## PARTS & SERVICE NEWS

REF NO.	AA02234
DATE	October 29, 2002

**SUBJECT:** HOIST CYLINDER CABLE BRACKET MODIFICATION

FIGURE 1. DUMP CONTROL LINKAGE

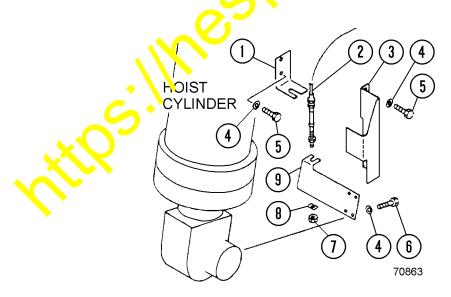
Some trucks have experienced problems with the hoist cylinder cable sligging out of place. Bracket (9, Figure 1) is attached to the rear of left hand hoist cylinder. The bracket has a slotted hole which holds the hoist cylinder cable (2) in place.

To secure the hoist cylinder cable, weld flat washer (2, Figure 2) over the slotted hole. The flat washer has an inner diameter of 20 mm. Position flat washer (2) or existing bracket (1) so that inside radii of flat washer and bracket are flush. Weld as shown in Figure 1.

In addition, a new bracket (EK3361) has been designed to replace bracket (1 Figure 2). Instead of a slotted hole, the new bracket will have a 20 mm diameter hole to hold the heist cylinder cable in place.
